Illinois Department of Transportation

SUBJECT: Chicago Executive Airport
Village of Wheeling / City of Prospect Heights
Cook County
Illinois Project Number: PWK-4843
SBG Project Number: 3-17-SBGP-TBD
Contract No. PA063
Item No. 08A, July 30, Letting
Addendum A

NOTICE TO PROSPECTIVE BIDDERS

Construction plan revisions and special provisions issued as Addendum A.

CONCRETE ELECTRICAL HANDHOLE DETAIL -
IDOT STANDARD NO. 814001
NOT TO SCALE

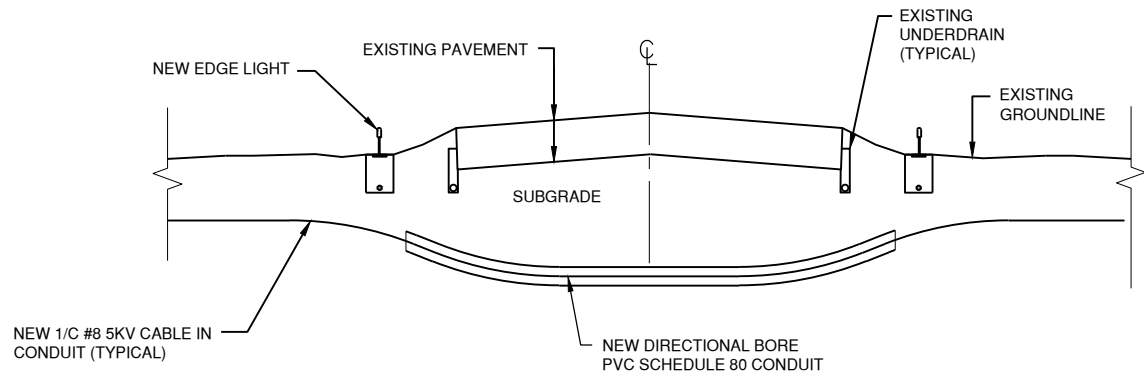
1. Revised Sheet 27 – “Electrical Details – Sheet 4”
 - Added Electrical Handhole detail.
2. Revised Sheet 28 – “Airfield Electrical Vault Improvements and New ALCMS”
 - Revised nomenclature no. 44.
 - Deleted note 10.
3. Revised Sheet 31 – “ALCMS – Equipment Block Diagram”
 - Deleted note 8.
4. Revised Sheet 23– “Additive Alternate #1 Beacon - Location Plan”
 - Revised details for “existing mounting platform” to “new mounting platform”.
 - Added detail callout for existing FAA obstruction light to be relocated.
